SERVICE LETTER: 92

EFFECTIVITY: AT-802A s/n 0217 and other AT-802As with similarly placed and caused welding cracks.

TITLE
DWG. SERVICE LETTER 92 IMAGES

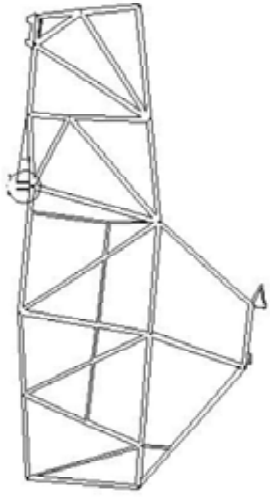
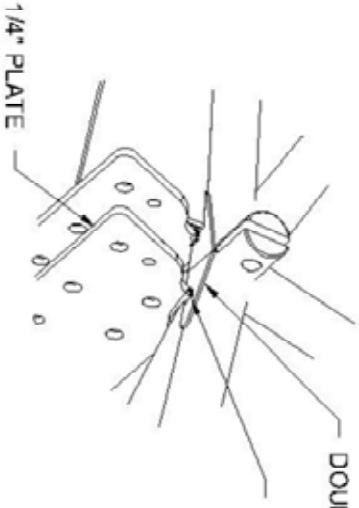
BACKGROUND INFORMATION: One aircraft, shown in included picture, has reported a crack at the point where the weld for the aft float attach bracket overflows past the doubler plate and onto the longeron tube. Only one aircraft has a confirmed crack of this type but any others with a similar crack should be repaired as per this service letter.

GRIND 1/4" PLATE AS SHOWN

METHOD OF COMPLIANCE: Carefully grind the existing weld down to the parent metal of the longeron at the point where the weld for the aft float attach bracket continues onto the longeron. Then the longeron needs welding and heat treatment repair for stress relief as per the included process specification instructions from Air Tractor to be done by an Air Tractor certified welder or equivalently certified structural welder.

GRIND BACK 1/4" PLATE AND OLD WELD TO CENTERLINE OF LONGERON TUBE. REPAIR OR PATCH LONGERON TUBE. REWELD 1/4" PLATE TO LONGERON DOUBLER. WELD ON 1/4" PLATE TO LONGERON DOUBLER AS SHOWN. WELD AND STRESS RELIEVE PER SNOW ENGINEERING SPECIFICATION # 120 & 125.
